ALTERATION TO A HISTORIC PROPERTY STAFF REPORT

Site: 201 Central Street 1919-1925 Temple B'nai Brith

Case: HPC 2015.090 City of Somerville Preservation Restriction

Legal Notice: Block two windows for installation of new elevator and replace one window with a door for new

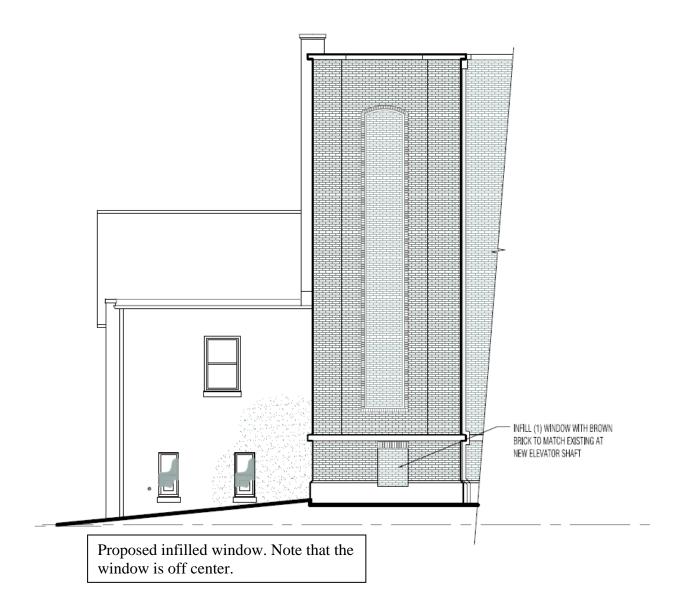
The sides of the building were not discussed in the Form B. While not discussed in the Form B, it is likely that the opening is not original to the building and indicated by its off-center location. No material will be removed from the portion of the building visible from the street only the rear addition where it would not be visible. A lower level window will be infilled with material to match the existing with shadow lines retained to show that there had been an opening at the rear northeast corner of the building.

Infilling the window opening completely with material to match the masonry wall does not meet the guideline to retain openings nor the guideline to retain the original window elements. The distance from the street and angle of view renders any window details moot. The window infill will be inset to retain the shadow of the opening and indicate its original location.

- 1. All appropriate building permits shall be obtained prior to the start of any work.
- 2. If the approval differs from the plans, new plans shall be submitted to Historic Staff prior to commencing the work;
- 3. The window at the northeast corner of the building abutting the driveway shall be infilled to match the masonry above in size, color, texture, mortar and pointing details.
- 4. The infill will be set to sufficient depth to retain the character of an opening as seen from Central Street.
- 5. Historic Staff shall issue a sign-off upon completion of the project that this was done in accordance with the Certificate and approved plans and prior to the Somerville Historical Society receiving Inspectional Service Division sign off.
